Zoning Staff Report

Case Number: ZC-25-206

Zoning Map Amendment

Case Manager: Joseph Laws
Owner: E Loop 820, LLC
Applicant: Leslie Ford, Ofi Chito
Site Location: 3812 E Loop 820 S
Acreage: 3.089 ac

NET LEASE PROPERTIES
E BERRY ST
SITE PLAN FOR PD
 FORT WORTH ZONING CASE #: ZC-##-###
 LOT 1, BLOCK 1
 BERRY COMMERCIAL ADDITION
 ULRICH WUTHRICK SURVEY,
 ABSTRACT NO. 1693
 3.089 ACRES
 CITY OF FORT WORTH,
 TARRANT COUNTY, TEXAS
 APRIL 10, 2026

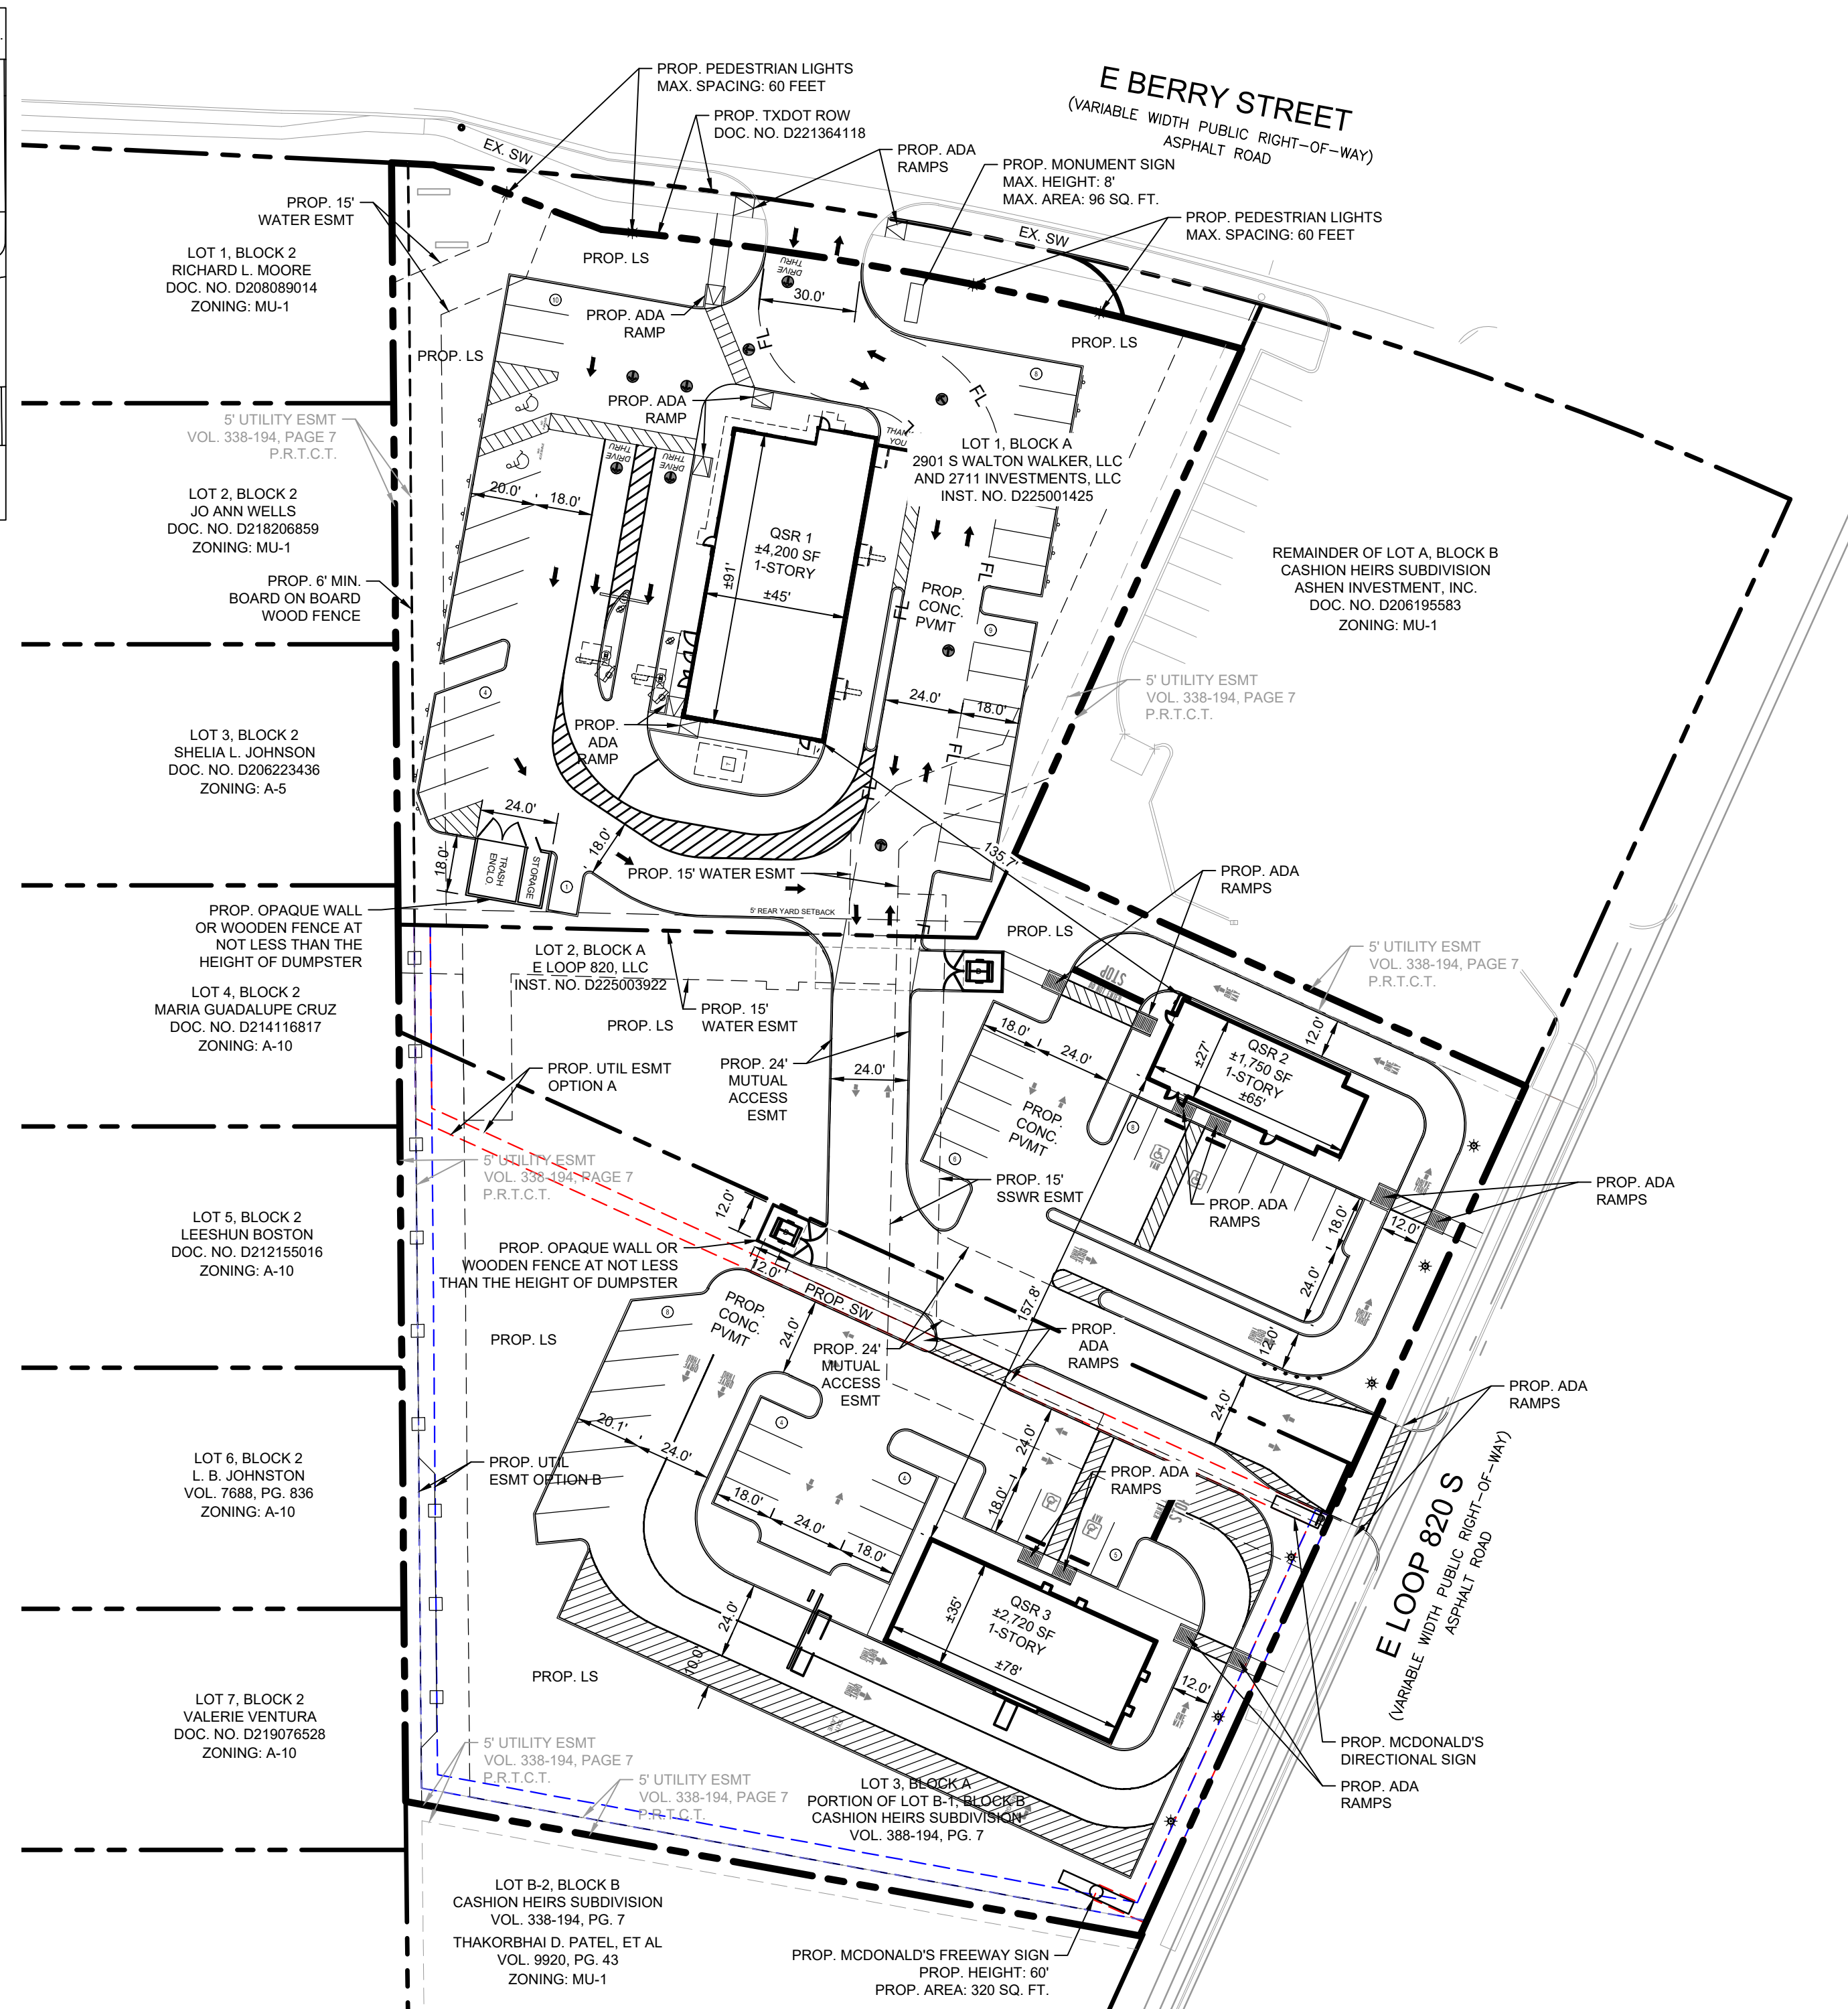
Several waivers have been identified on this proposal:

- § 4.1300(d)(2) —Primary Street Setback (0’/20’ min/max)
- § 4.1300(e)(3)a—Surface parking prohibited between building front and street
- § 4.1300(e)(3)f—Max surface parking frontage: 40% primary street / 70% side street
- 4.1300(f)(1)a-c—Passenger car parking, automobile and truck access and loading or unloading of goods only allowed within the 20’ building setback areas during the daylight hours
- 4.1300(f)(2)b-c—Street trees and pedestrian-scaled lighting along all public ROW
- 4.1300(g)(5)a—Main entrance from a public sidewalk or plaza
- 4.1300(g)(5)b—Primary entrances shall not be from a parking lot
- 4.1300(h)(6).1—Drive-through windows and stacking lanes shall not be on facades facing a street; shall be located to the rear where possible
- 4.1300(h)(6).2—Driveways shall not be in front yard setback between building front and street

Each lot must have one point of access. Lot 2 and Lot 3 on FP-25-231 must have a recorded mutual access easement either by plat or separate legal instrument.

Building hose lay must be provided within 150’ from a marked fire lane or public street for non-sprinklered buildings. 300’ may be allowed for buildings having fire sprinkler systems.

Hydrant requirements are as follows. Additional hydrant(s) will be required.

FYI - Per Fire, additional fire hydrants are required.

FYI - Sewer Extension is required to every proposed lot to the end of the lot line per city-accepted construction plans. Provide a community facilities agreement (CFA) or miscellaneous project (MP) for sewer improvement. No water/sewer on the side or back of lots per Subdivision Ordinance §31-81 (Water & Sewer Design §3.3.1).
